CONCEPT 3 - APPROVED "J" SCHEME

Design Response Conference

DATE: 04-16-2018

CDCMASSING CONCEPT - APPROVED SCHEME

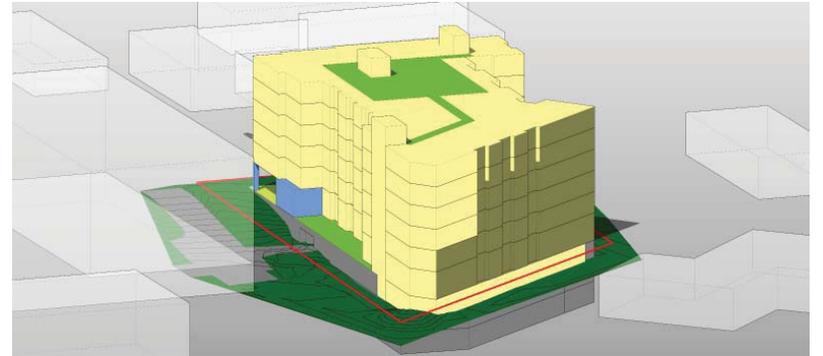
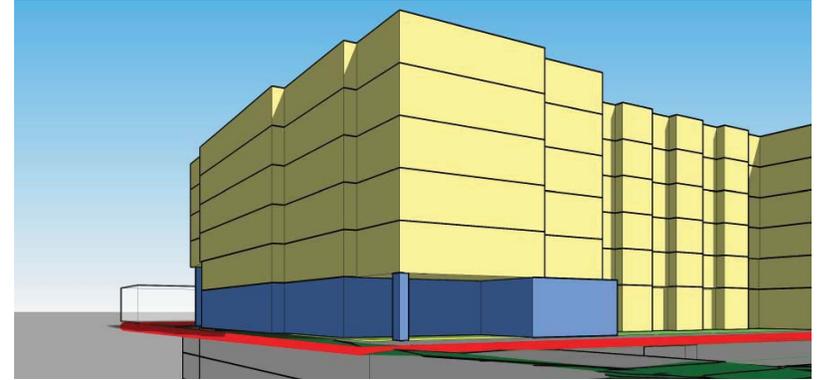
BOARD GUIDANCE:

A. BUILDING MASSING

- Take cues from the adjacent Lennar project, particularly in respect to streetscape, however the building design should stand by itself.
- Develop rhythm and interest for NE 128th streetscape facade.
- Provide organization and pattern to the NE 128th streetscape facade.
- Create a well designed storefront character along the pedestrian oriented sidewalk.
- Provide texture and modulation, avoid flat facades.
- Develop rooftop treatment, how the building meets the sky.

B. BUILDING MATERIAL AND DETAIL

- Provide texture and detail with particular attention for the pedestrian experience; texture of materials, quality of finishes, small, decorative elements.
- Ornament and applied art, integrated with building design and site environment.
- Use a range of colors compatible with a coordinated color scheme.

C. PEDESTRIAN ORIENTATION

- Provide texture on sidewalk.
- Review artwork opportunities along NE 128th frontage.

DESIGN DEVELOPMENT - RESPONSE:

A. BUILDING MASSING

- Created corner condition for mid-block site at intersection of shared vehicular drive/project access. Locate pedestrian plaza/pocket park and pathway connection at this "corner" location.
- Corner emphasis with massing and recessed balconies to overlook "eyes on the street" of the public sidewalk, plaza and pedestrian connection.
- Stepped massing at street frontage provides organization of the parts of the facade and provides variation and interest along the streetscape.
- Texture and modulation provided with varied materials and color, stepped facade, recessed bays and windows, balconies, decorative screens and play of shadow.
- Varied parapet heights and projecting soffit elements provides interest and scale for the overall building massing.

B. BUILDING MATERIAL AND DETAIL

- Varied texture and color of materials (brick, smooth panel siding, lapped siding and woodtone lapped siding), quality finishes, and decorative elements are proposed throughout.
- Decorative artwork metal screens are integrated with building design and site environment.

C. PEDESTRIAN ORIENTATION

- A variety of paving patterns have been utilized to identify uses: paving at plaza extends out to sidewalk to draw pedestrians in, emphasis at building entry, distinction between curb zone and movement zone.
- Decorative screens are used a varied of ways along the NE 128th frontage, providing pedestrian scaled interest texture and shadow play.

INTERIOR LOT LINES

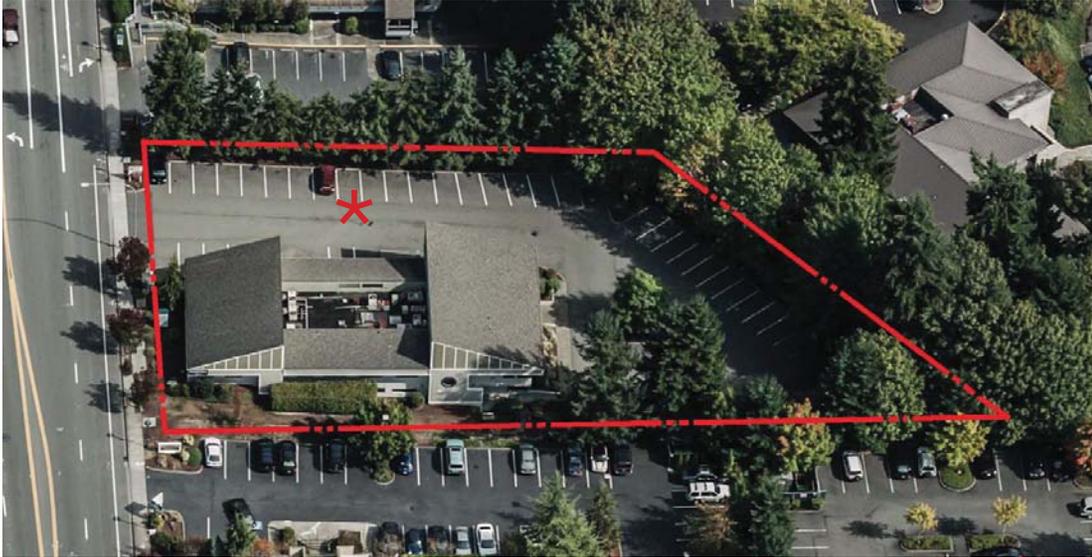
BOARD GUIDANCE:

C. PEDESTRIAN ORIENTATION

- Through block pathway should be cohesive in design and provide true amenities to enrich the pedestrian experience.
- Southern terminus should end at SW property corner for future development.
- Treatment of the west side of building facade is critical for pathway success.

D. PUBLIC IMPROVEMENTS AND SITE FEATURES

- Lighting, benches, paving, waste receptacles and other site elements are important aspect of the pedestrian-oriented business district character. In addition to the 128th street frontage, these elements will be important for the through-block pathway and fire lane improvements.

E. OPEN SPACE AND LANDSCAPING

- Explore activating the fire lane space with materials other than turf pavers to provide opportunities for both passive and active recreational uses.
- Increase presence of evergreens in the planting list.

DESIGN DEVELOPMENT - RESPONSE:

C. PEDESTRIAN ORIENTATION

- The through-block pathway is connected to the public plaza / pocket park which has been integrated into the streetscape design and building design through special paving design, artwork decorative screen elements and adjacent open spaces. A variety of amenities are provided to enrich the pedestrian experience; including multiple seating and gathering spaces, outdoor fireplace, artwork screens, unique overhead lighting and an overlook view of the pathway, seating nodes, dog park and landscaping to the south.

- The southern terminus ends at SW property corner for future development.
- The west side of building facade has unit balconies and terraces above, overlooking the pedestrian pathway. Overhead canopies for scale and weather protection have been provided at doorway connections to the path. Additional detailing has been provided with a board-formed concrete texture on the exposed garage wall. Large flowering shrubs will help to screen the wall (trees not allowed in waterline easement).

D. PUBLIC IMPROVEMENTS AND SITE FEATURES

- Lighting, benches, paving, waste receptacles are included at the through-block pathway and fire lane improvements.

E. OPEN SPACE AND LANDSCAPING

- The fire lane is provided with hardscape that will provide opportunities for both passive and active recreational uses. A basketball hoop has been provided at the covered fire lane.
- Evergreen plantings have been increased in the planting list (see landscape sheets.)

MALL VIEW OFF TOTEM LAKE BOULEVARD

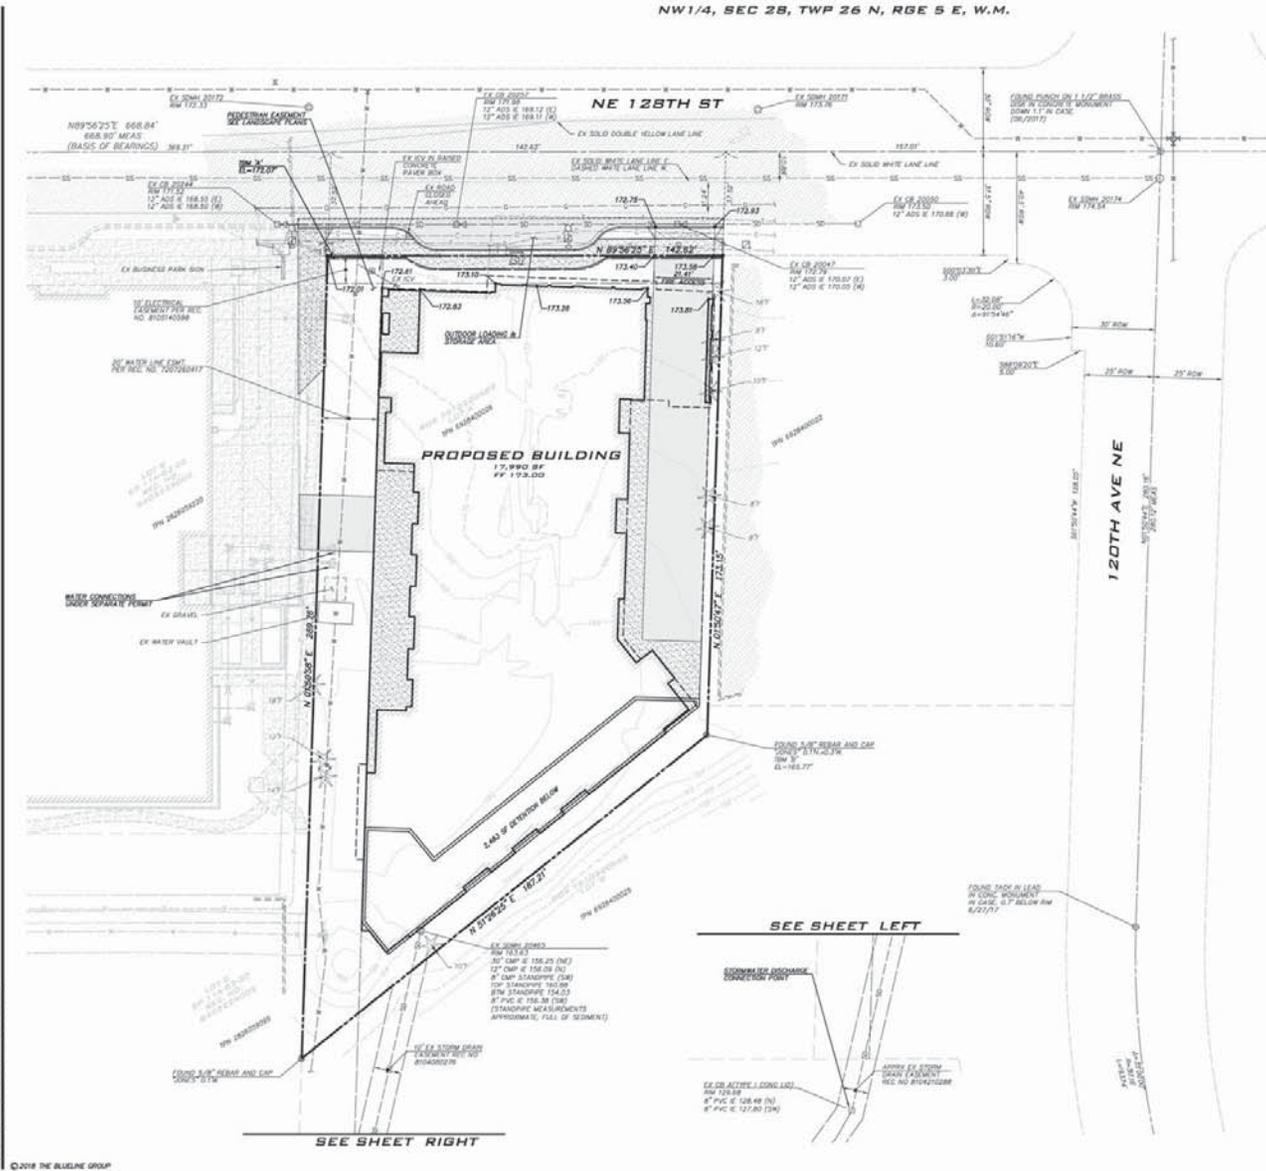
BOARD GUIDANCE:

- The south facade is the tallest portion of the proposed project with seven levels of units on this frontage. The adjoining properties to the south are situated downslope from the property. Consideration should be given to this "backside" facade and it's visual impacts on properties to the south.
- Provide views of the south facade of the project from the Totem Lake Mall.

- looking north east

- The view of the proposed building from the Totem Lake Mall off of Totem Lake Boulevard will likely be screened by the existing mature vegetation and trees on the adjoining south property.
- The re-development of the mall with 6-7 story structures behind the existing 1 story mall buildings will provide scale & context for the proposed project.
- The "grid-iron" prow corner of the proposed buildings will be visible through the trees providing a unique and interesting view.

NE 128TH STREET - STREETScape CONTINUITY

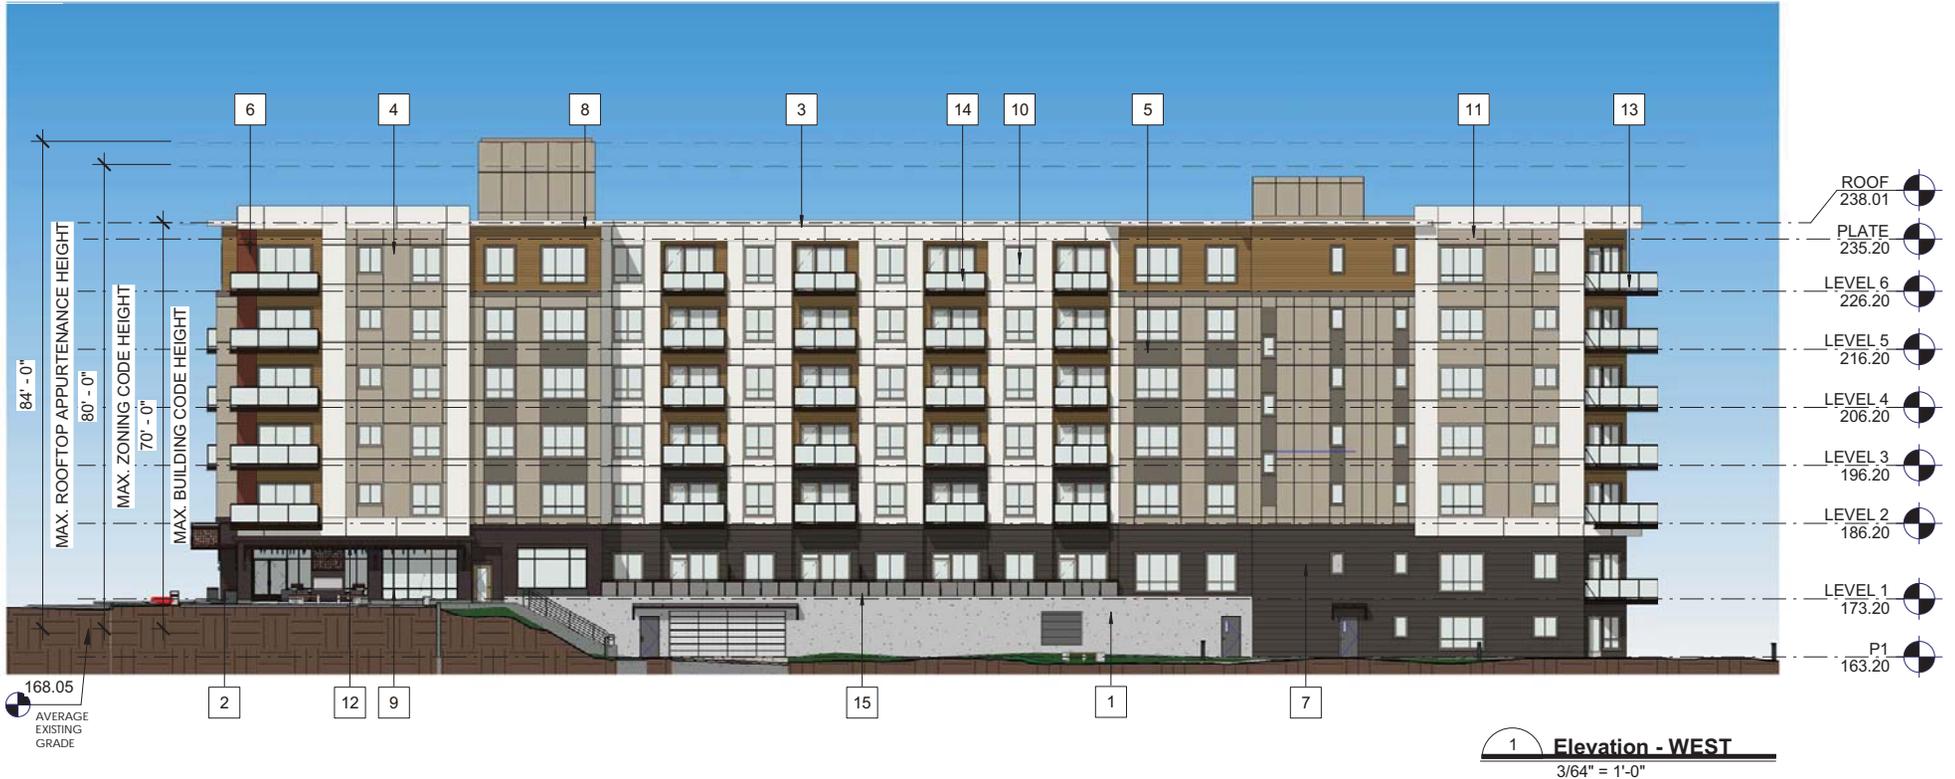
BOARD GUIDANCE:

- Take cues from the adjacent Lennar project, particularly in respect to streetscape, however the building design should stand by itself.
- Develop rhythm and interest for NE 128th streetscape facade.
- Provide organization and pattern to the NE 128th streetscape facade.
- Create a well designed storefront character along the pedestrian oriented sidewalk.
- Provide texture and modulation, avoid flat facades.
- Develop rooftop treatment, how the building meets the sky.

RESPONSE:

- PEDESTRIAN FRIENDLY BUILDING FRONTAGE:
 - Canopies
 - Storefront Glazing / Active Uses
 - Art Elements
 - Benches, Planters
 - Indoor/Outdoor Connection
 - Upper levels overlook, corner balcony, Juliette balconies
 - Distinctive rooftop features
- CUES FROM LENNAR DEVELOPMENT
 - Set building to 10 setback
 - Stepped vertical modulation
 - Provide depth in facade above street
 - Contrast strong horizontal "white box" expression with vertical corner treatment
 - Provide horizontal modulation with recessed facades, windows, balconies and attic story for finer texture and shadows.
 - Utilize a compatible color scheme with use of Woodtone siding and white panels, but use warmer colors and pops of accent color.
